DISPOSAL OF GOVERNMENT-OWNED LAND AND IMPROVEMENTS -
MDB-260-97

Building 779, Decommissioning Waste Management Plan

Review Comment Sheet
Richard Fox, CDPH&E - Comments to draft 980 PAM

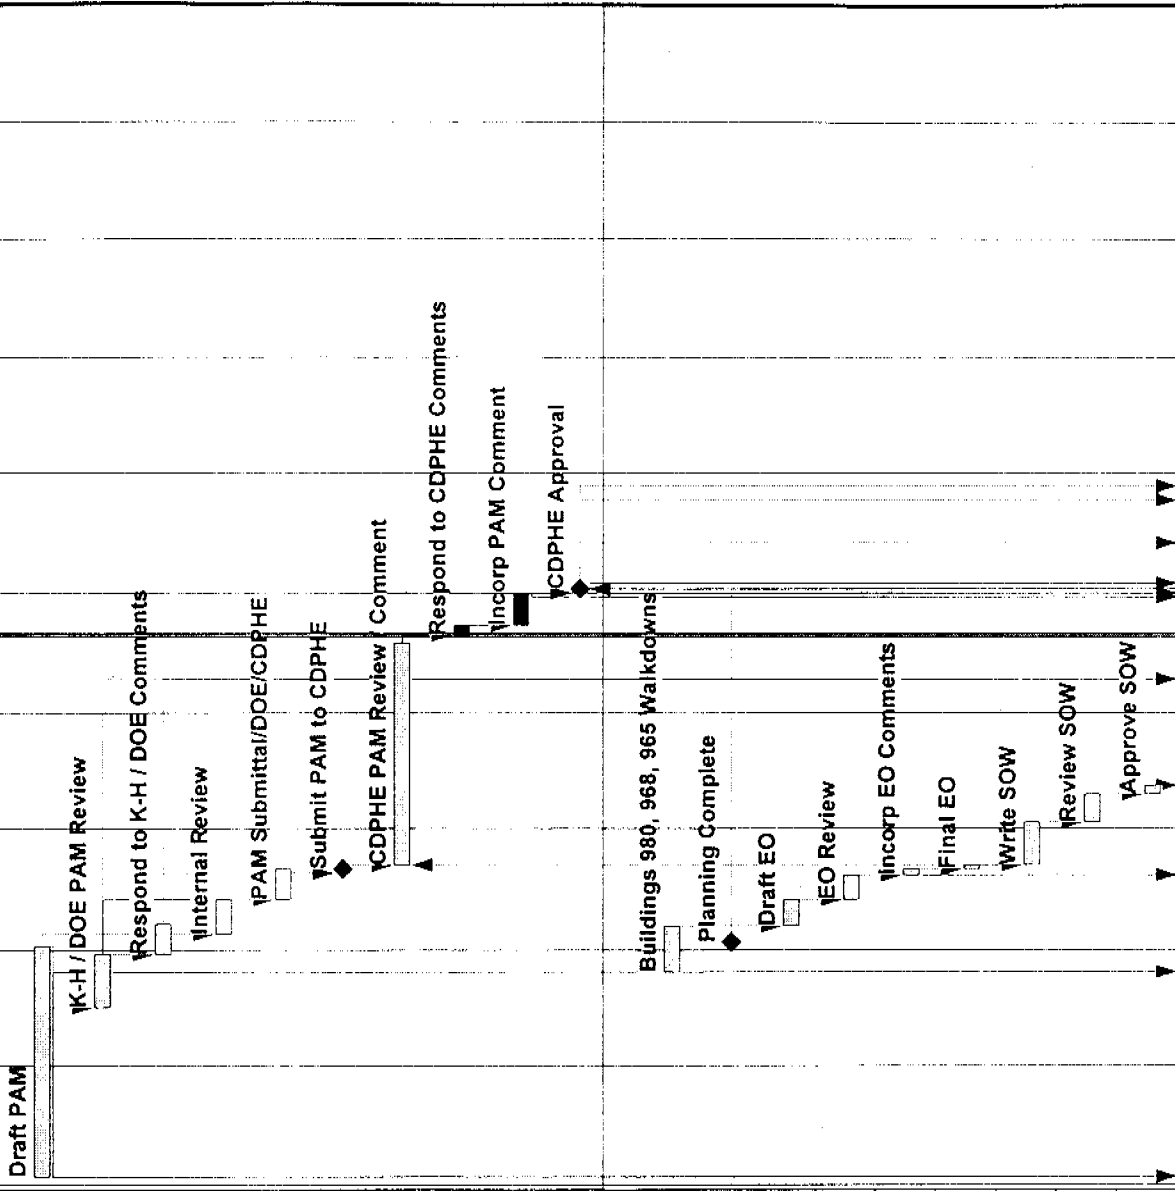
5. Figure 6-1, Schedule Layout: The schedule shows that the Reconnaissance Level Characterization Report (RLCR) was to be submitted at the end of April, prior to submitting the PAM to CDPHE. Do we have a copy of the RLCR? If not, we should request it.

5. Figure 6-1, Schedule Layout: The schedule shows that the Reconnaissance Level Characterization Report (RLCR) waste to be submitted at the end of April, prior to submitting the PAM to CDPHE. Do we have a copy of the RLCR? If not, we should request it.
